**CITY OF SAINT PAUL  
HERITAGE PRESERVATION COMMISSION STAFF REPORT**

FILE NAME: 51 Seventh Street West, Church of the Assumption School  
DATE OF APPLICATION: July 18, 2014  
APPLICANT: Bryan Horton, Renewal by Andersen  
OWNER: Church of the Assumption  
DATE OF PUBLIC HEARING: September 11, 2014  
HPC SITE/DISTRICT: Church of the Assumption – Individual Site  
CATEGORY: Contributing  
CLASSIFICATION: Building permit  
STAFF INVESTIGATION AND REPORT: Christine Boulware, John Beaty  
DATE: September 5, 2014

**B. PROPOSED CHANGES:** The applicant is proposing to replace 27 windows on the

**Previous Job  
Completed in 2007  
Under Permit #2007184031**

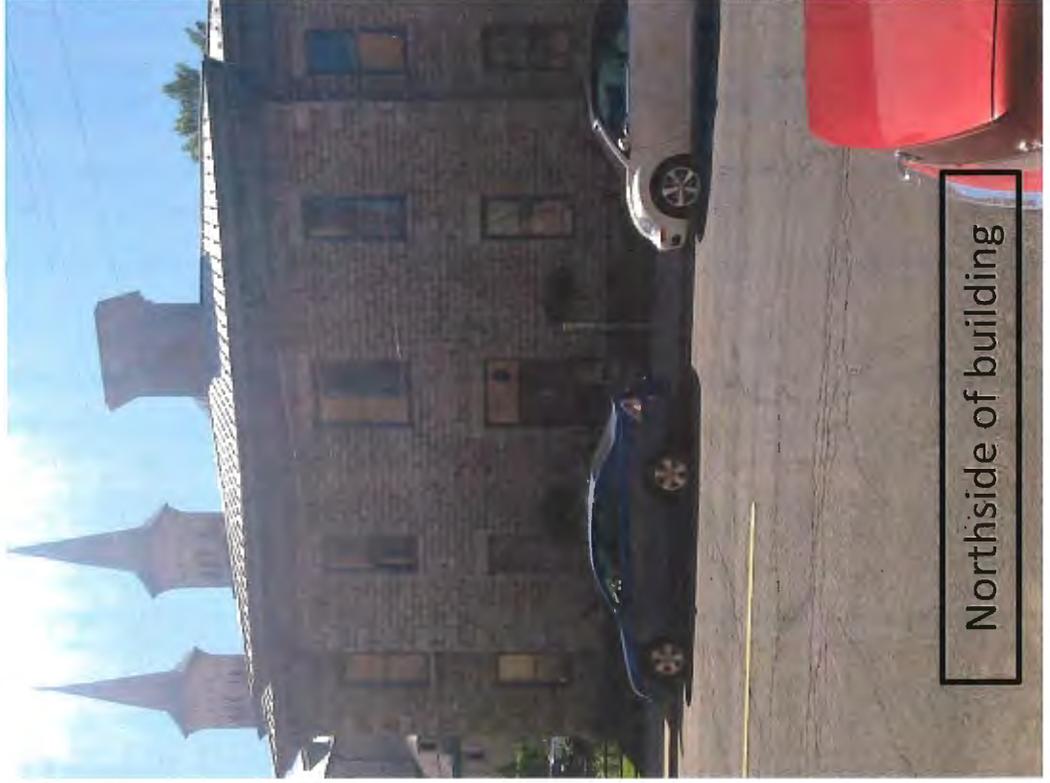
4. Building permit #07-184031/HP File#07-204258, referenced in the application, was for work to be performed on the 1941 Rectory Building. The Assumption School is the oldest building extant at the property and work on the building is reviewed differently than that on the rectory. The application of aluminum wrap on the window trim and brickmould is not an appropriate treatment for the Assumption School. Wrapping the exterior of the windows, trim and brickmould does not preserve the building in a manner consistent with the original design intent and does not comply with the preservation program.

# Sash/Frame Condition Details

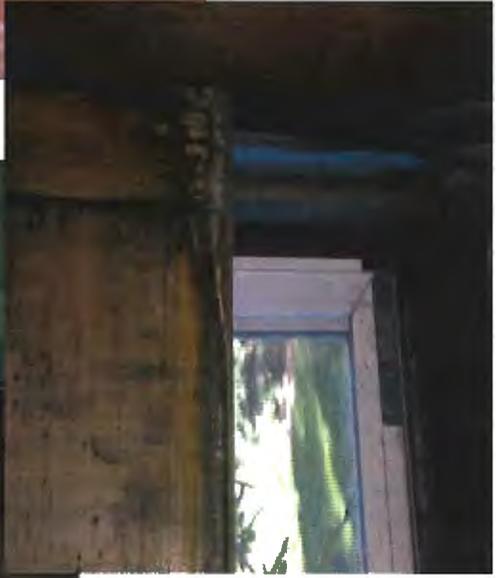
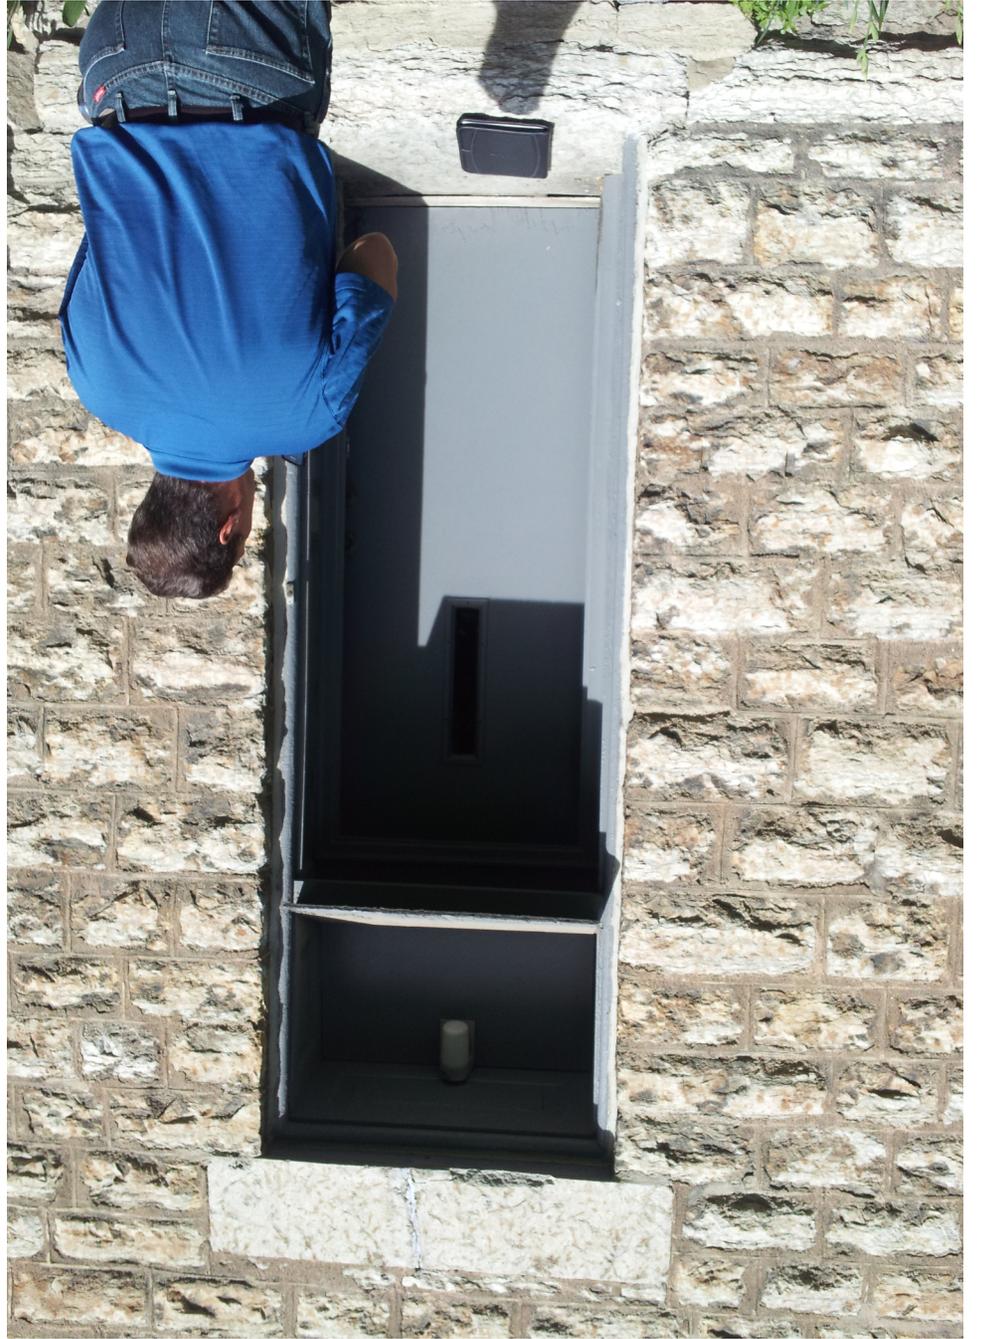
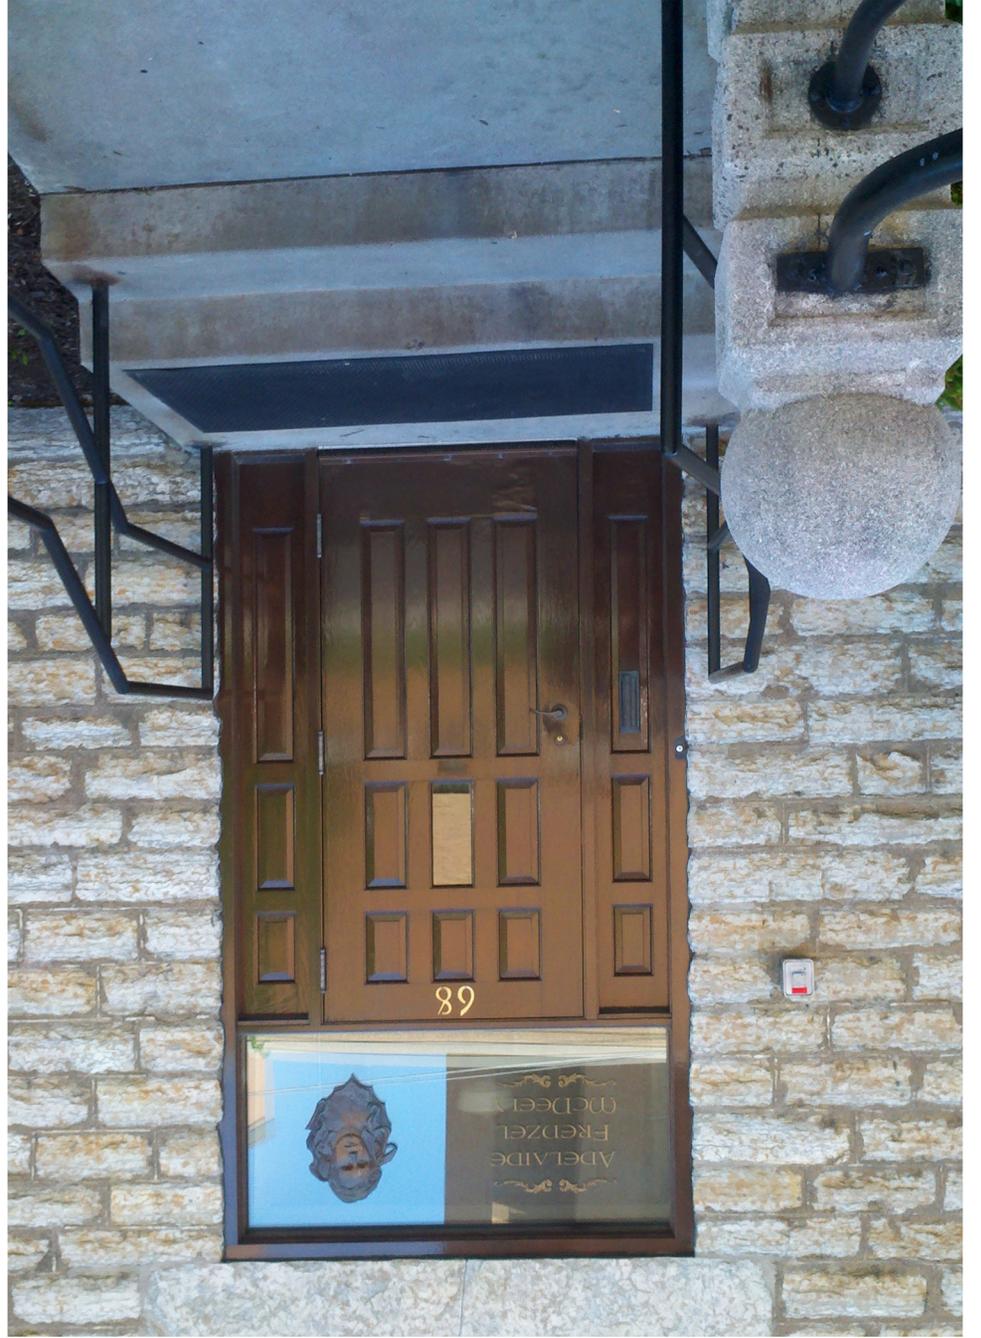
6. There are no historic screens or storm windows evident at the school building. The existing windows appear to have a profile that is consistent with the profiles shown in the 1936 HABS drawings. Photos submitted of the existing windows do not demonstrate conditions that warrant replacement. Staff did not conduct a site visit to observe the age and condition of the existing windows and a window schedule identifying the condition of each window and repair options/estimates were not submitted for review. The replacement of all of the windows does not comply with Standard #6 which states, "*Deteriorated historic features shall be repaired rather than replaced. Where the severity of deterioration requires replacement of a distinctive feature, the new feature shall match the old in design, color, texture, and other visual qualities and, where possible, materials.*"

Staff encourages the property owner explore repair of the existing windows and replacement in-kind where justified.

TYPICAL WINDOW DETAIL  
 SCALE 3"=1 FOOT

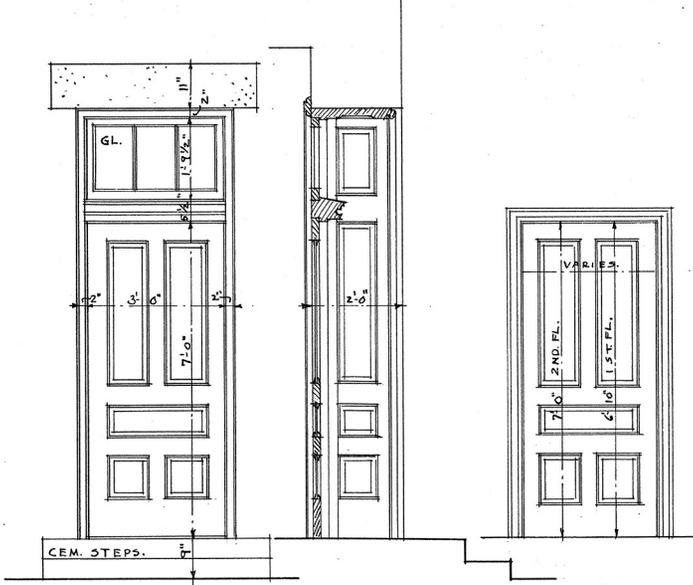
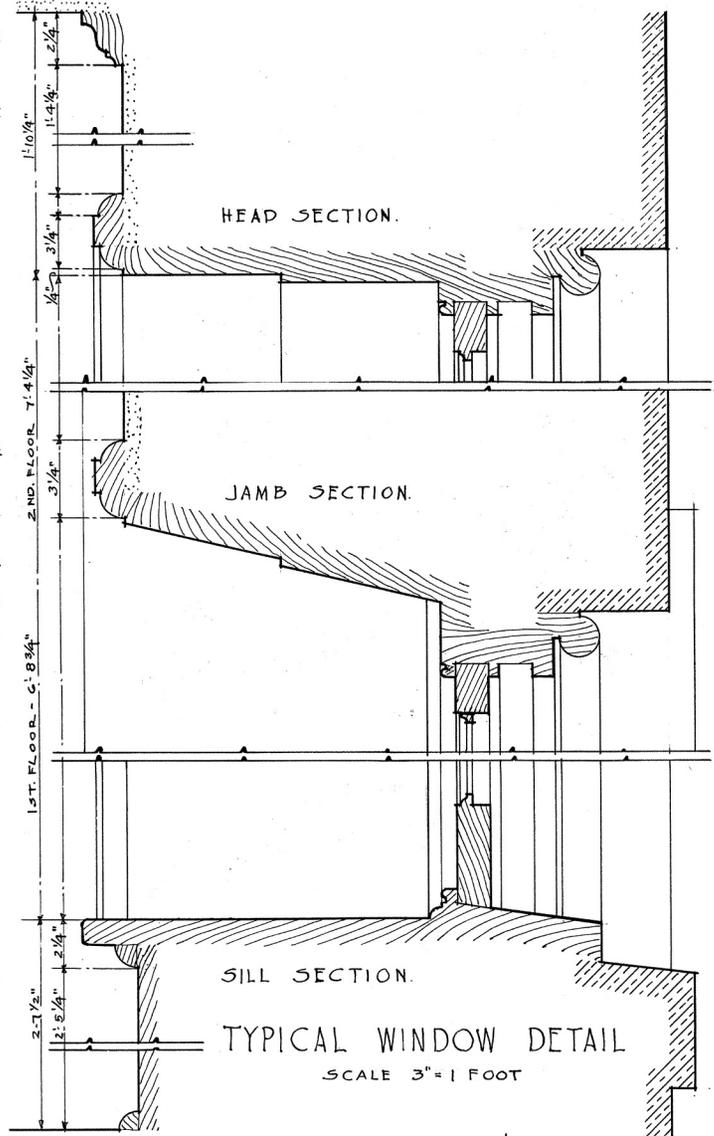
5. The architectural conditions of Assumption School were documented in 1936 as part of the Historic American Buildings Survey (HABS) program. The drawings depict a distinctive three-quarter round bead detail on the brick molds and heads of the window architraves. The application of aluminum wrap would obscure or result in the loss of this detail and is not consistent with the original design intent, thus does not comply with the preservation program.

Based on the findings, staff recommends denial of application to replace windows and wrap the exterior of the window trim and brickmould with aluminum.
